_	Case No.:	
Fee: \$750.00	MAR 2 8 2023	Date File	l:
	Zoning Board of Ap Village/Town of Mount		
	Village/Town of Mo		
	Municipal Buil		
	104 Main Street, Mt. Kiso	co, NY 10549	
	Zoning Board of A		
	Application	1	
Appellant: DP 21, LLC			
	ford Road, Suite 145, Moun		
Address of subject proper	rty (if different): 333 Nor	rth Bedford Road, M	ount Kisco, NY 1054
Appellant's relationship t	to subject property: X	Owner Les	ssee Other
Property owner (if different Address:	ent): Same as above		
	ZONING BOARD OF AP Building Inspector, <b>Peter</b>		
dated 09/06/2019	. Application is hereby	made for the follow	ving:

WITHIN 1,470± SF TELECOMMUNICATIONS

SITE 180 S. BEDFORD RD. ADDRESS: MT. KISCO, NY 10594

3 TYPICAL SIGNAGE C-6 SCALE : N.T.S.

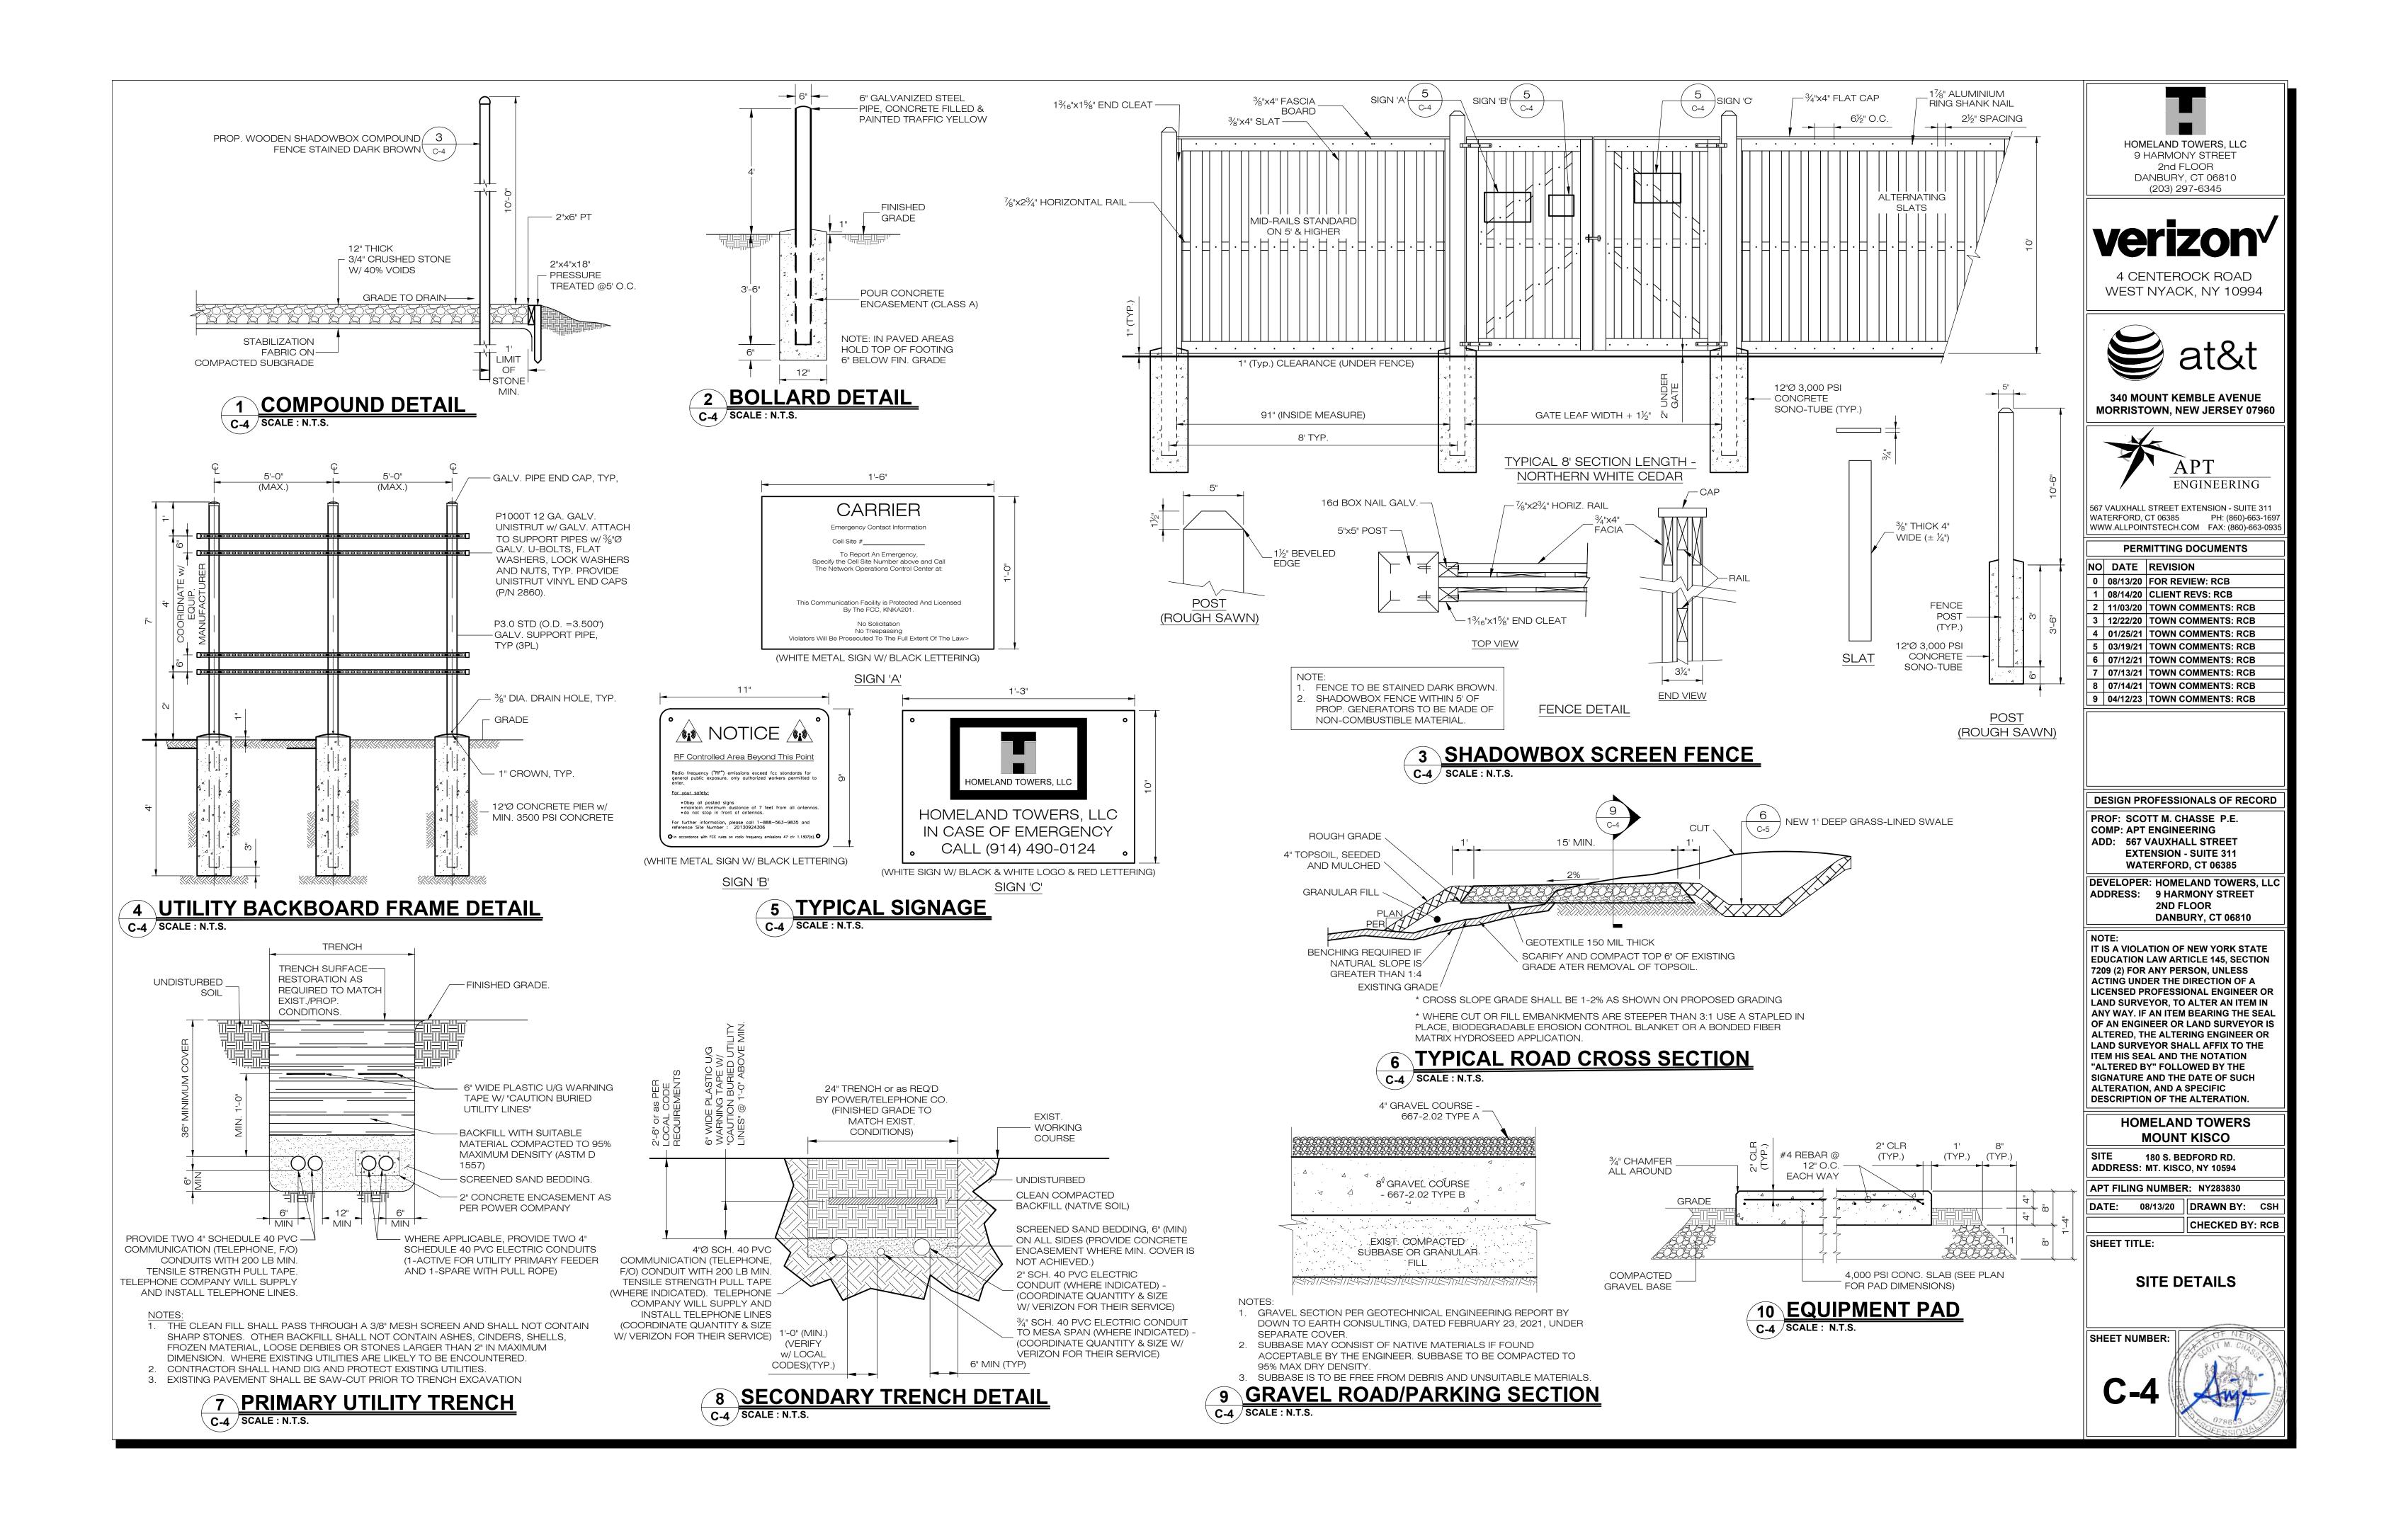
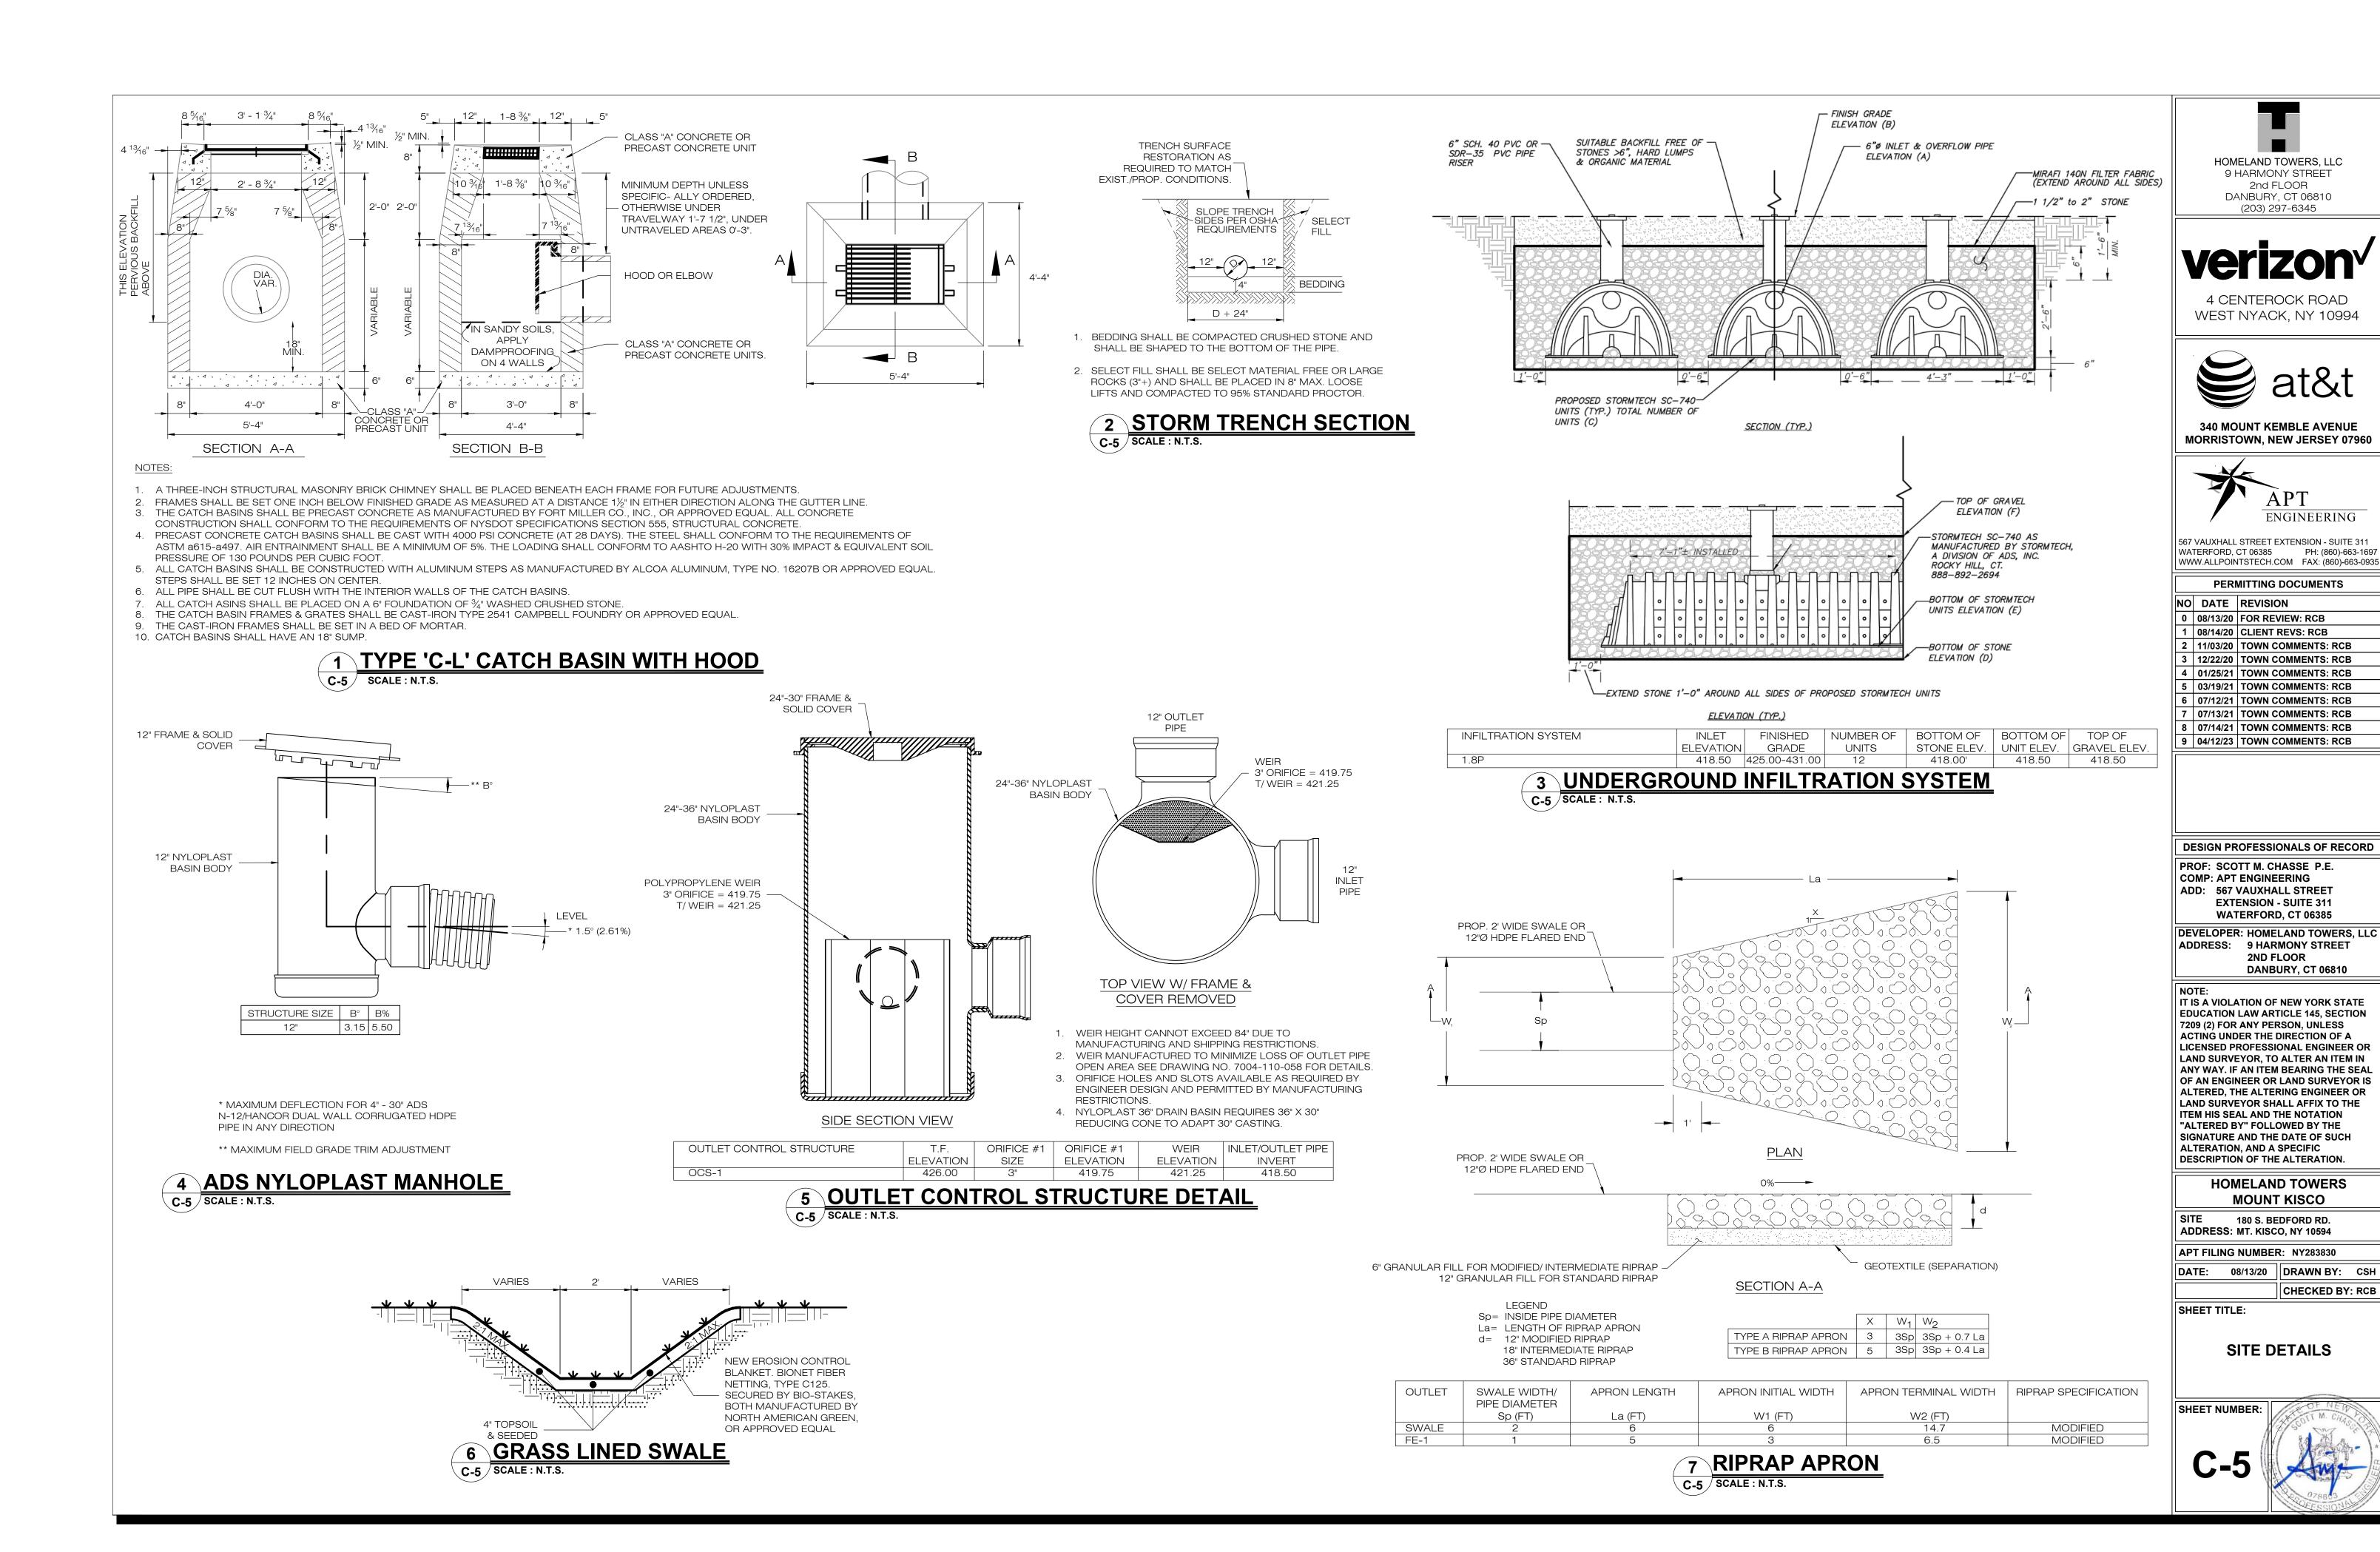
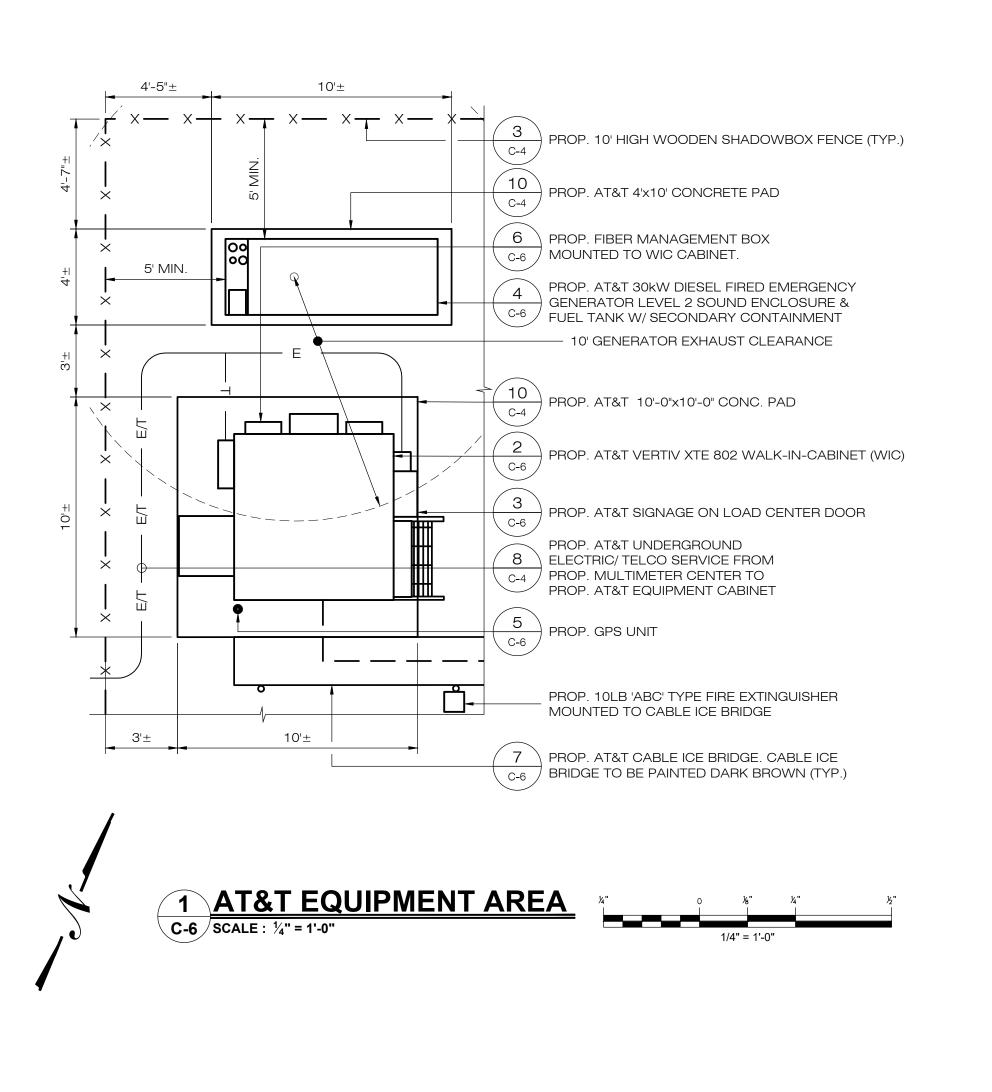
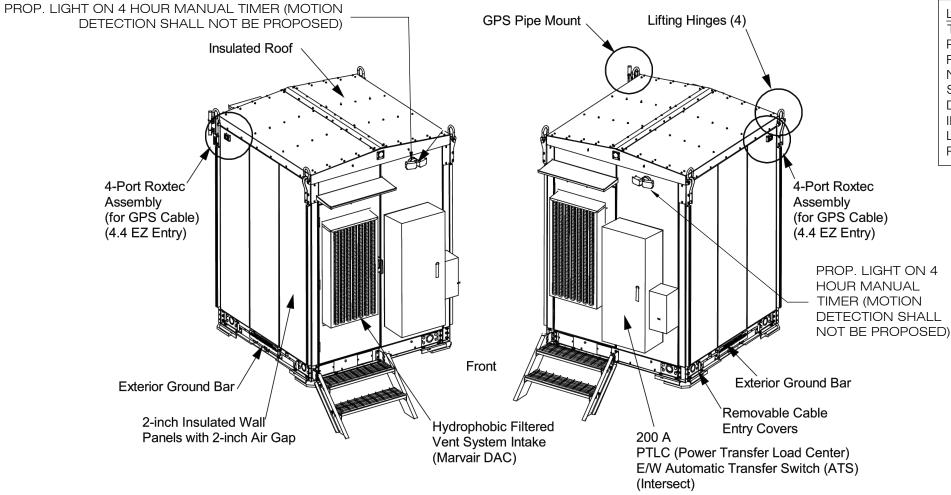
- Add note The equipment cabinet canopies and ice bridge shall be treated as a dark brown to match the compound fencing color
  - The drawings have been revised to specify that the proposed equipment canopies and ice bridges are to be painted dark brown (see Drawings C-1 and C-6).

Copy above generator notes to this sheet.
 A note regarding the proposed generator testing/cycling have been added to Detail 8 on Drawing C-1 and Detail 4 on Drawing C-6.
